MISSISSIPPI DEPARTMENT OF TRANSPORTATION

PROJECT: **STP-0055-02(271) / 108168301 –Madison County**
STP-0055-02(275) / 108168302 – Madison County

Add 2 Lanes to I-55 from SR 463 to Gluckstadt Road, & Mill & Overlay approximately 0.77 miles on I-55 from Gluckstadt Road north, known as Federal Aid Project Nos. STP-0055-02(271) / 108168301 & STP-0055-02(275) / 108168302 in Madison County.

SUMMARY OF REVISIONS

SHEET ID
PMD-1

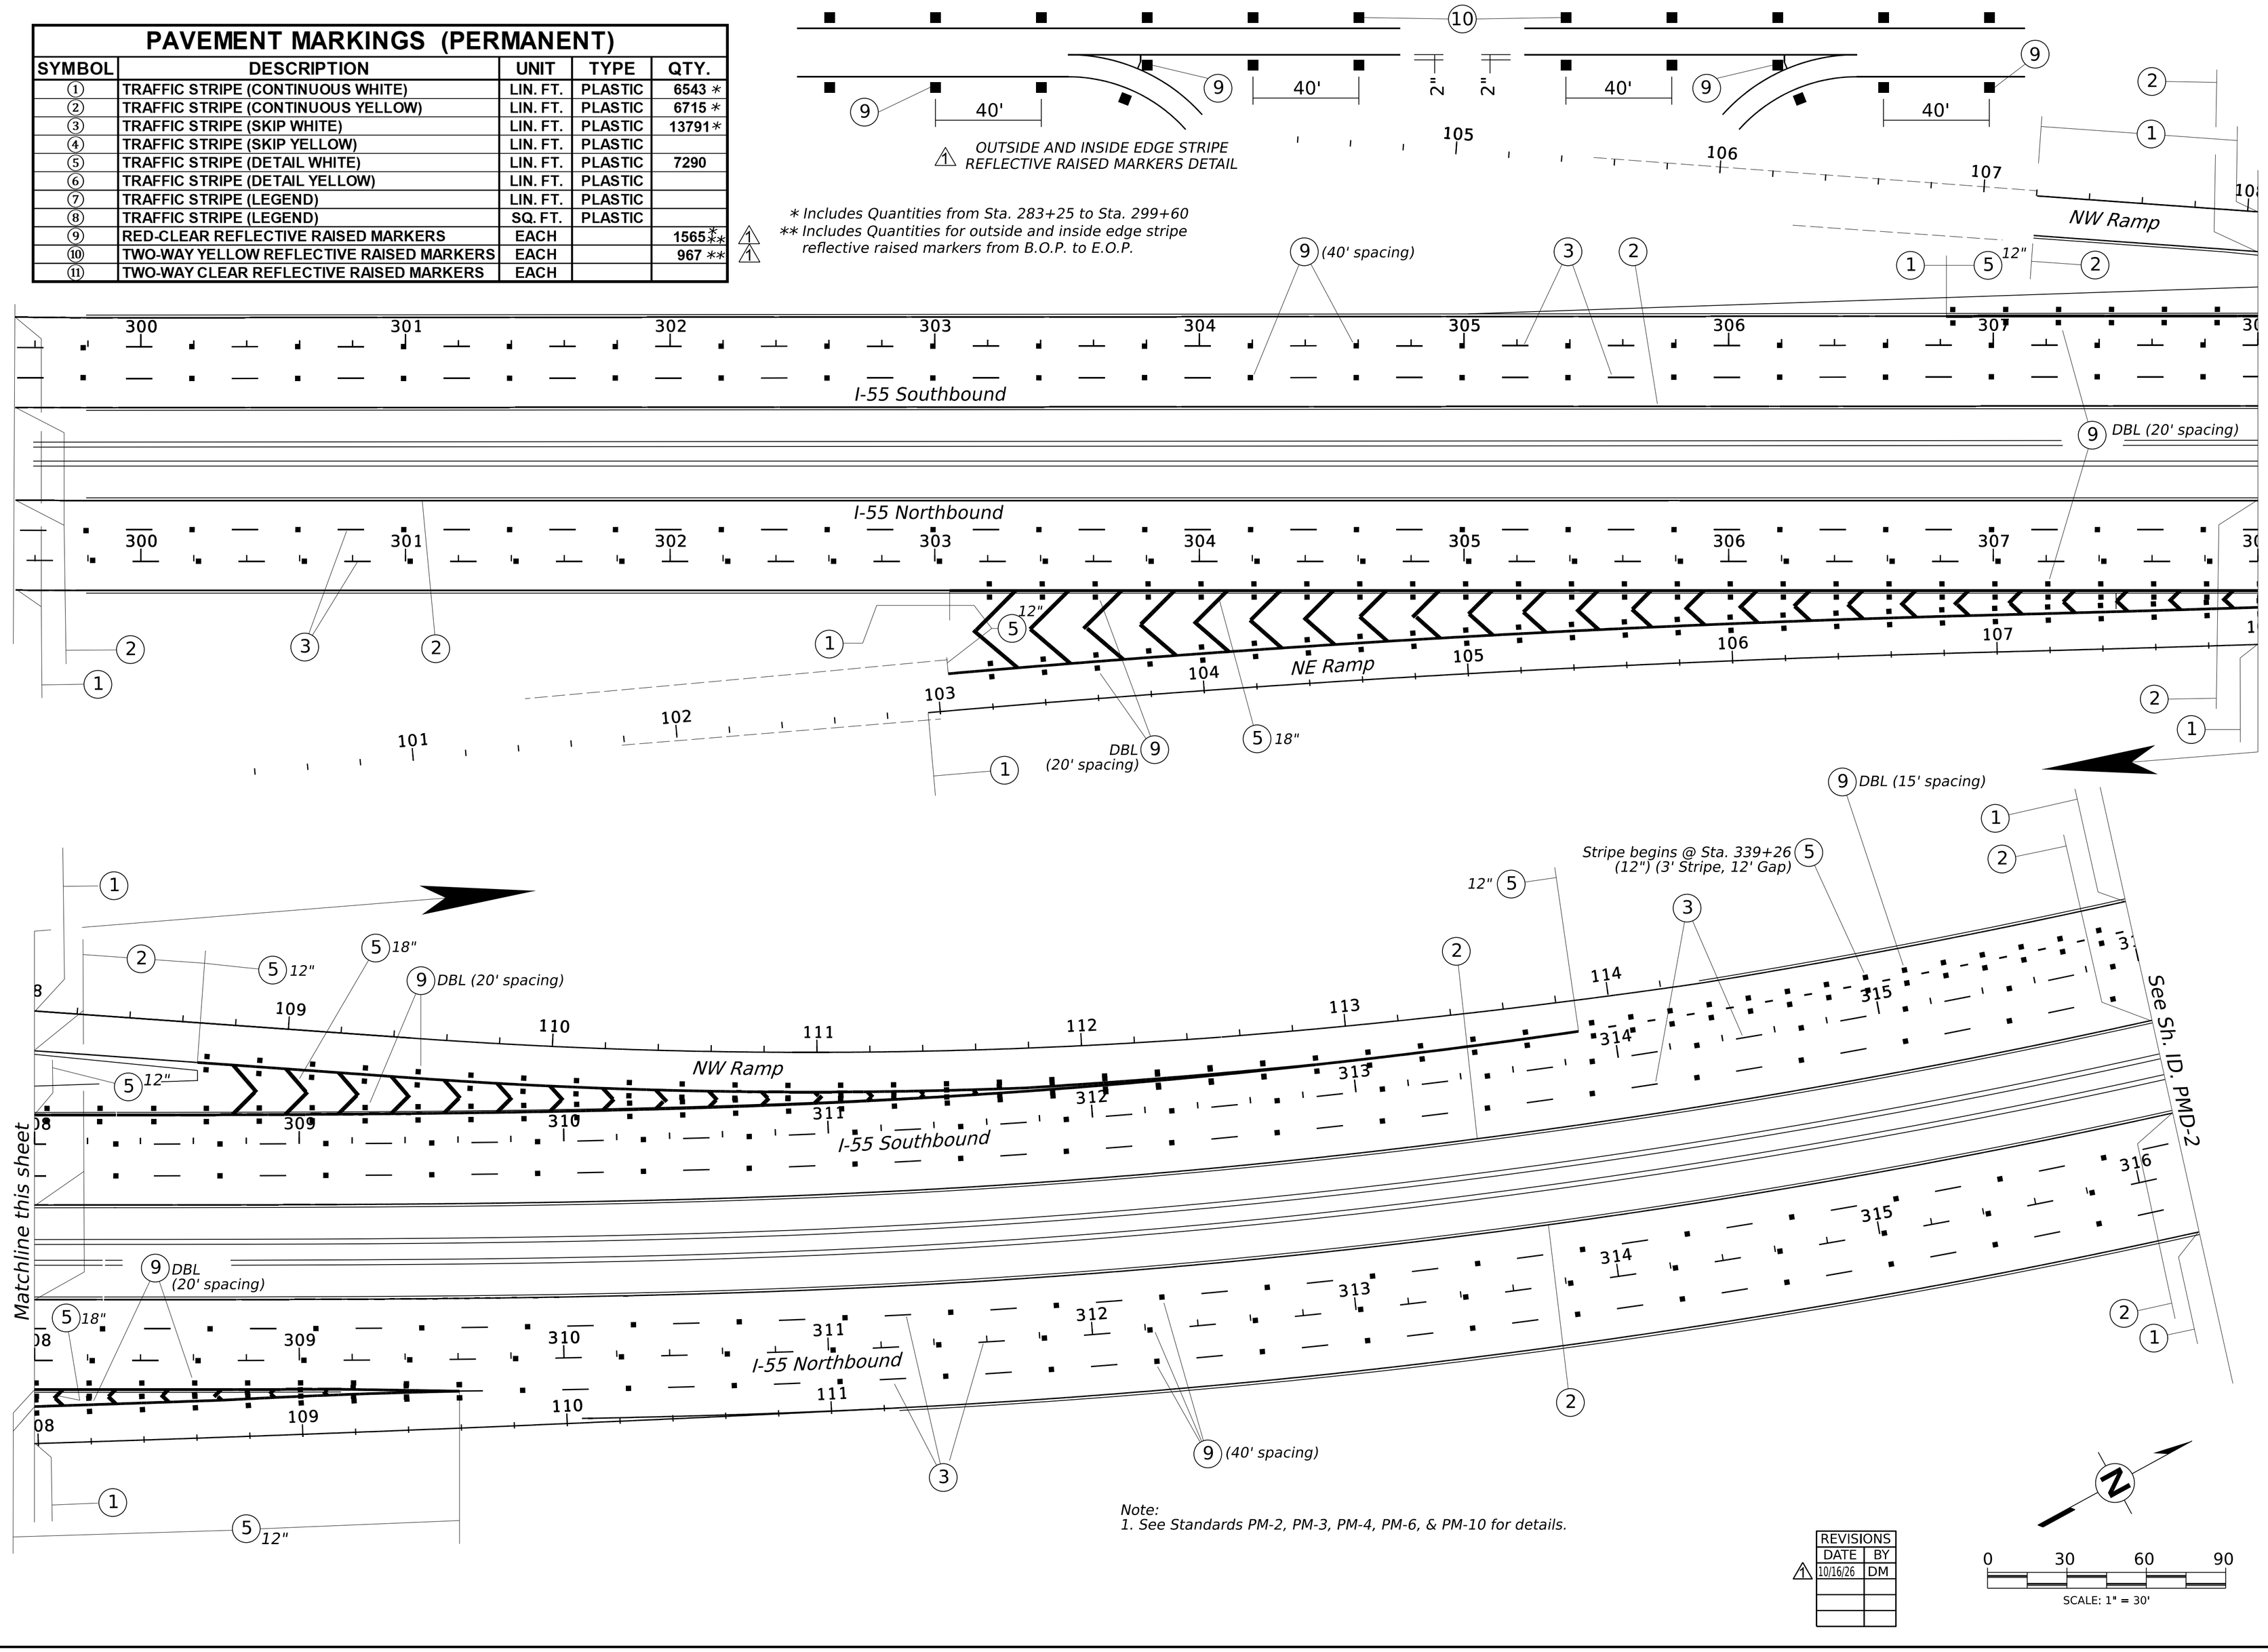
⚠1 OUTSIDE AND INSIDE EDGE STRIPE REFLECTIVE RAISED MARKERS DETAIL

⚠1 ⚠1 * Includes Quantities from Sta. 283+25 to Sta. 299+60
** Includes Quantities for outside and inside edge stripe reflective raised markers from B.O.P. to E.O.P.

SHEET ID **PMD-7**

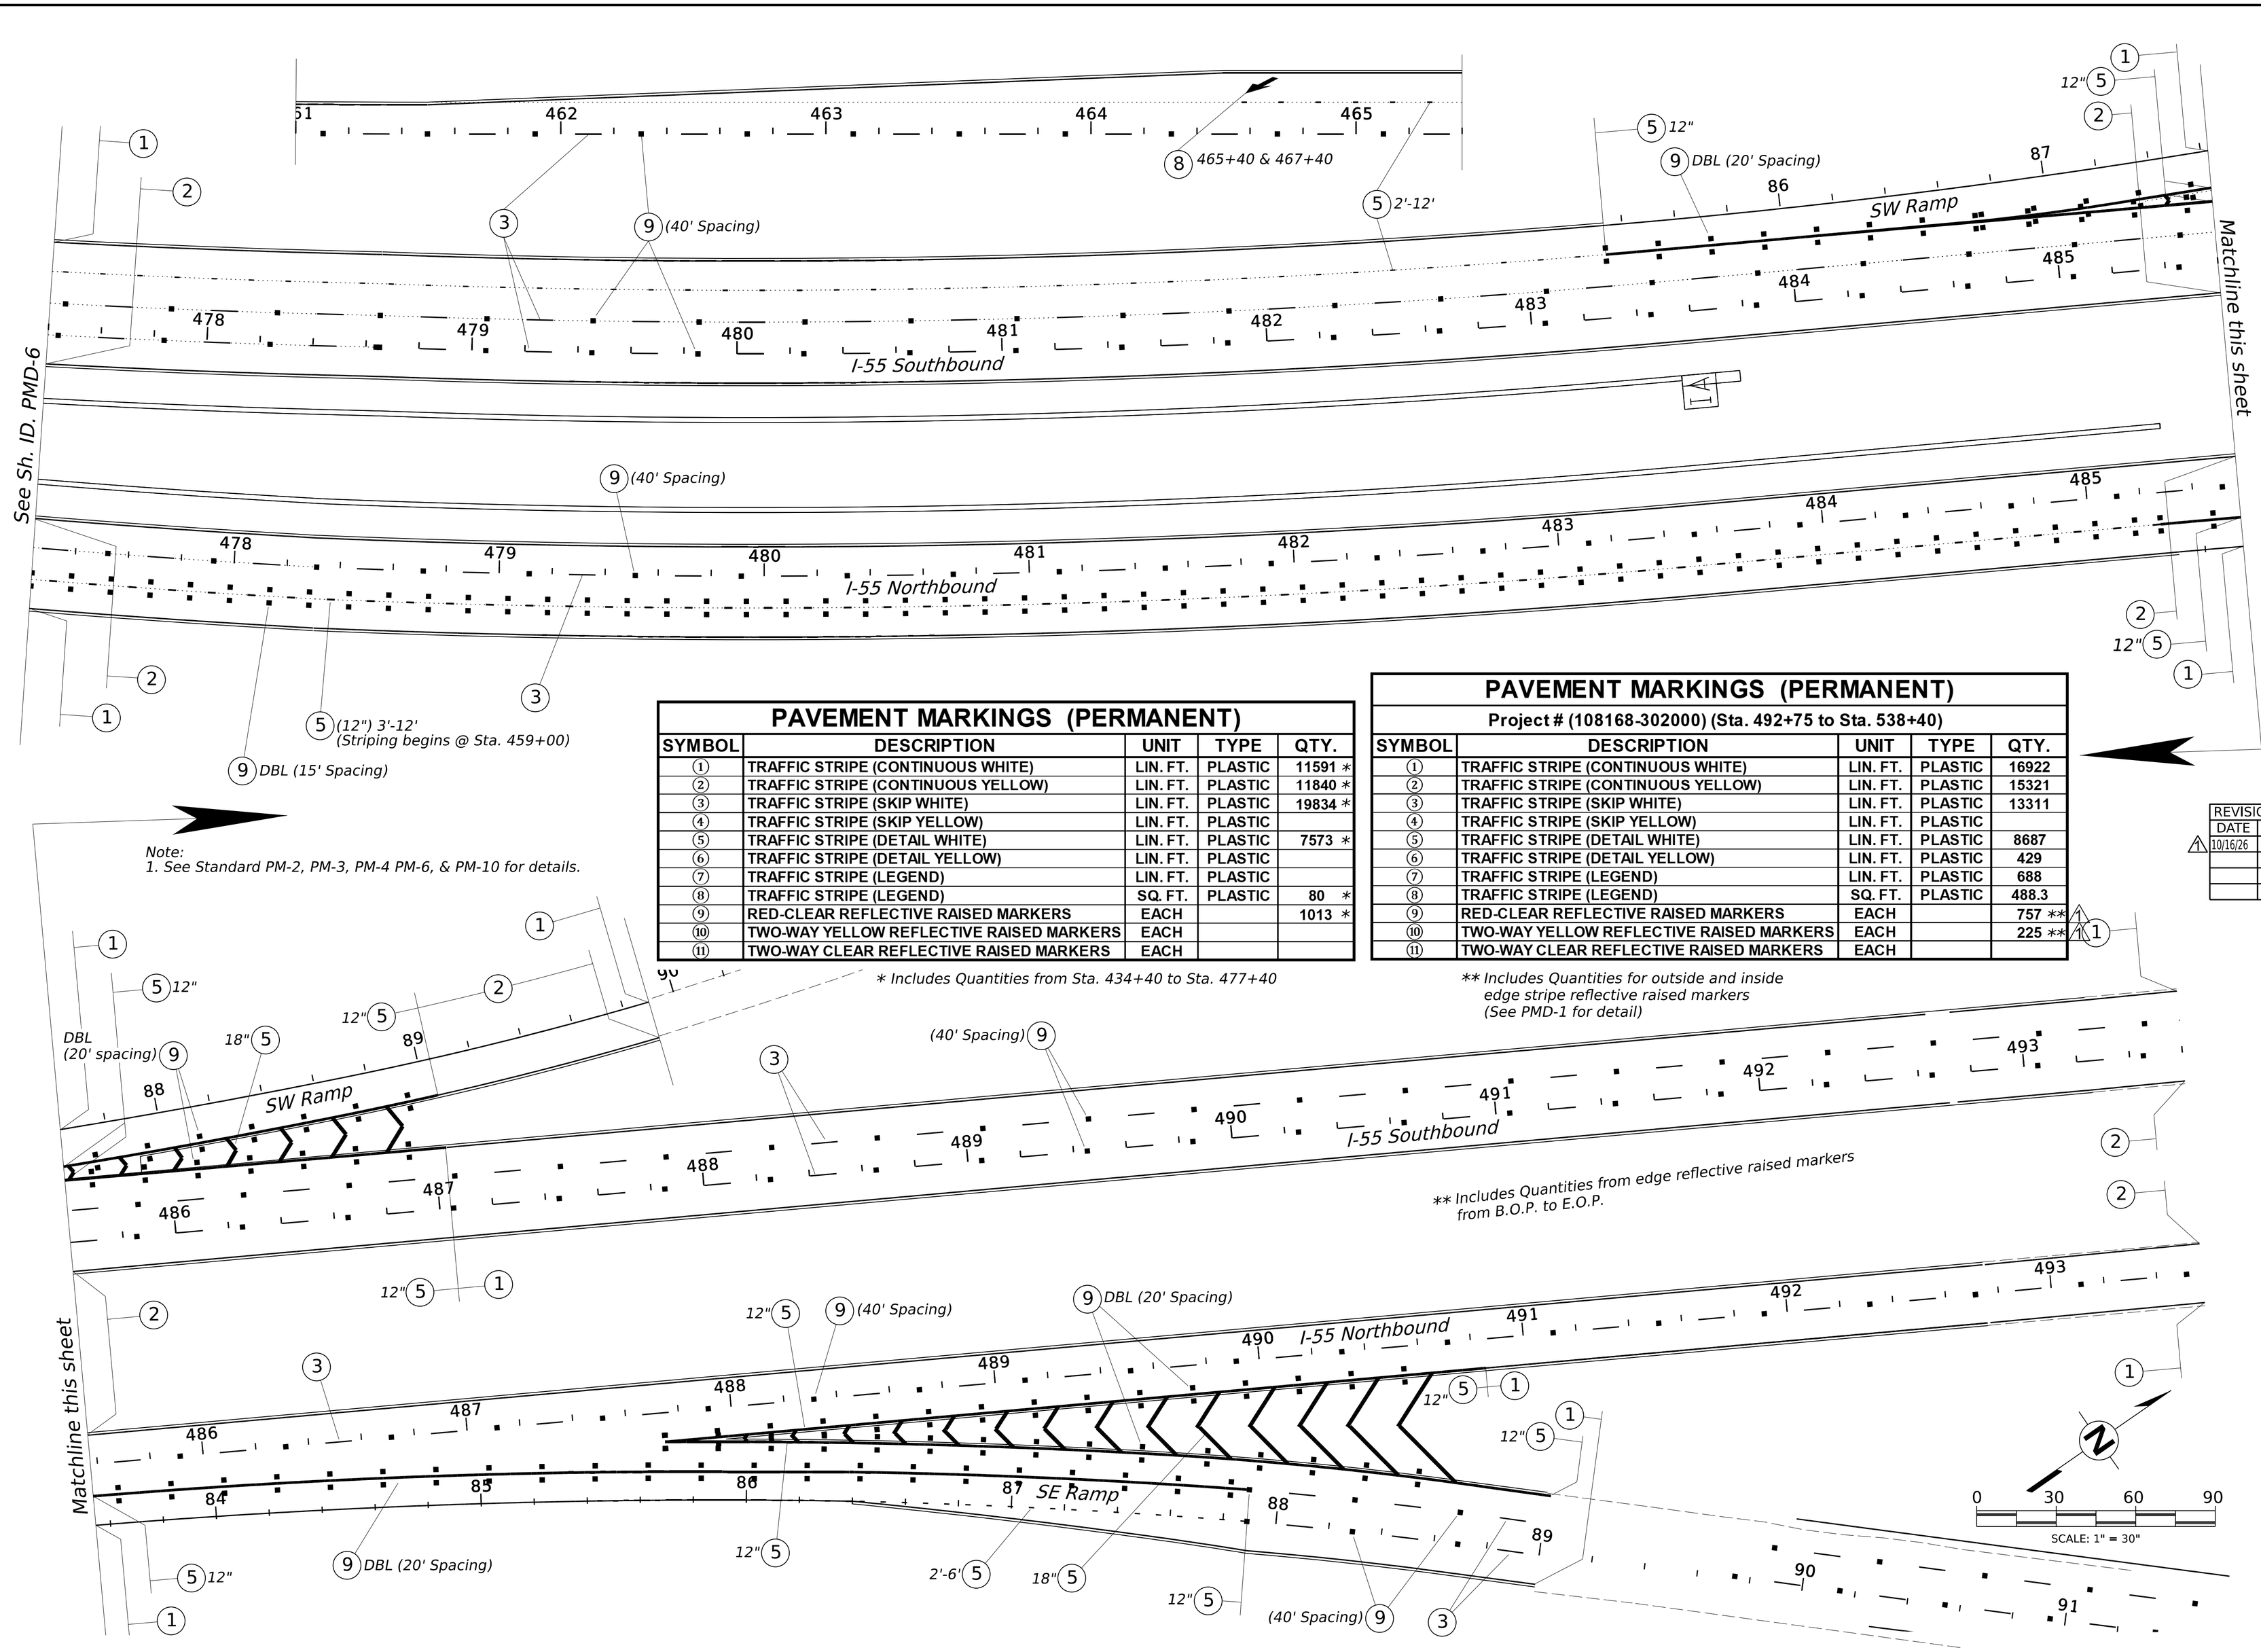
** Includes Quantities for outside and inside edge stripe reflective raised markers (See PMD-1 for detail)
